STAFF ANALYSIS

CASE NO.:	SLUP-26-1247921	File ID #: 2026-0146
Address:	1313 & 1303 Lithonia-Industrial Boulevard, Lithonia 30058	Commission District: 5 Super District: 7
Parcel ID(s):	16 164 02 007 & 16 164 02 005	
Request:	A Special Land Use Permit (SLUP) to allow a recycling plant (recycling concrete business) in the M (Industrial) zoning district.	
Property Owner(s):	SAWA Partners, LLC	
Applicant/Agent:	SAWA Partners, LLC	
Acreage:	38.3	
Existing Land Use:	Vacant Land, Structure, and Transportation Equipment Storage	
Surrounding Properties:	North: N/A—Avondale Estates; South: Gas Station; East: Multi-Family Apartments; West: Retail & Single-Family Residential	
Adjacent Zoning:	North: M South: N/A City of Stonecrest East: M West: M & M-2	
Comprehensive Plan:	LIGHT INDUSTRIAL (LIND) <u> X </u> Consistent <u> </u> Inconsistent

REPLY TO STAFF ANALYSIS

PETITION NO: N9-2026-0146 SLUP-26-1247921

C1.0

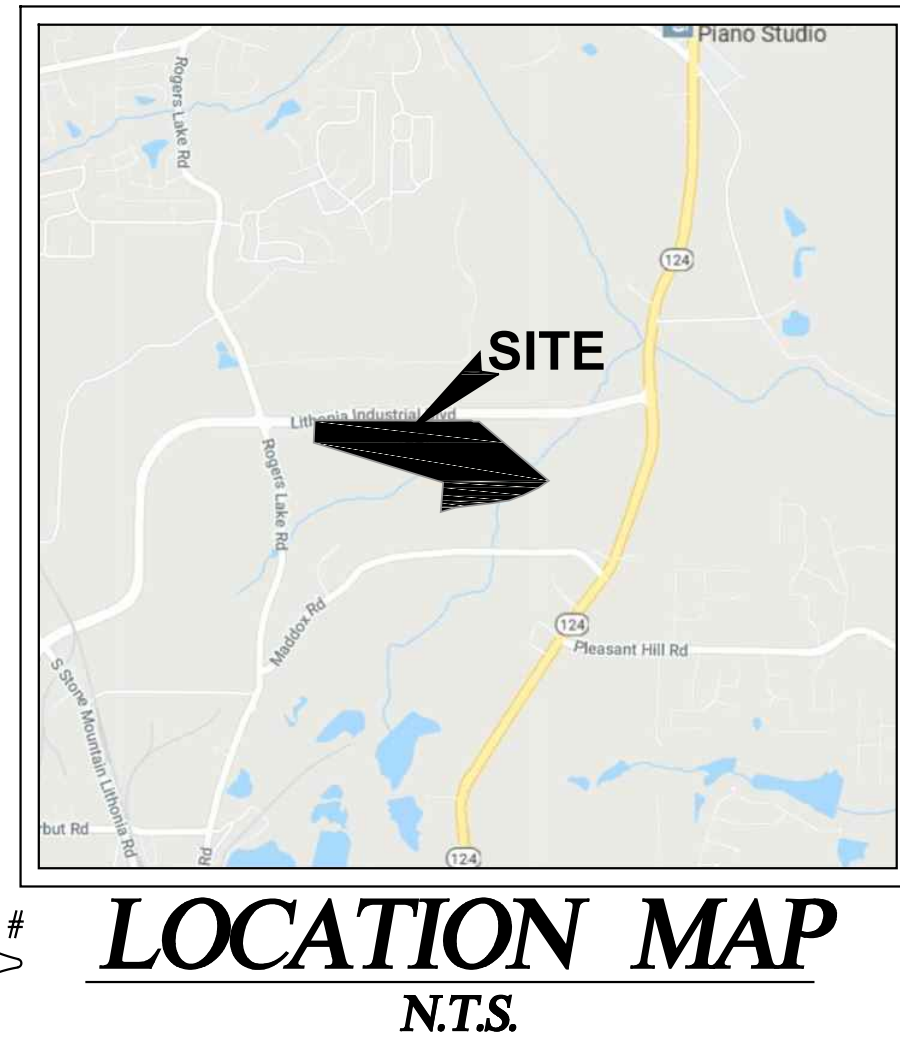
5. Show how trucks will enter and exit the property, noting on the plan where the paved surfaces for the transportation equipment storage will be located, and clarify whether the secondary curb cut off Lithonia Industrial Boulevard will be used for the proposed operation.

Lithonia-Industrial Boulevard is classified as a “Minor Arterial” road. Not enough information to properly review. Access points were set based on the Lithonia Industrial Blvd Road Plans. Applicant does not show interior routes on plans. Streetlights will be required on Lithonia-Industrial Boulevard.

- **The entrance into property is already paved with concrete. According to our site plans, and the site plan shows the entrance and exit will be paved with concrete. Also a secondary curb cut off will be necessary for a exit out of the property.**
- **Heavy equipment such as excavators and dozers have track chains which can not be stored on concrete nor paved areas.**
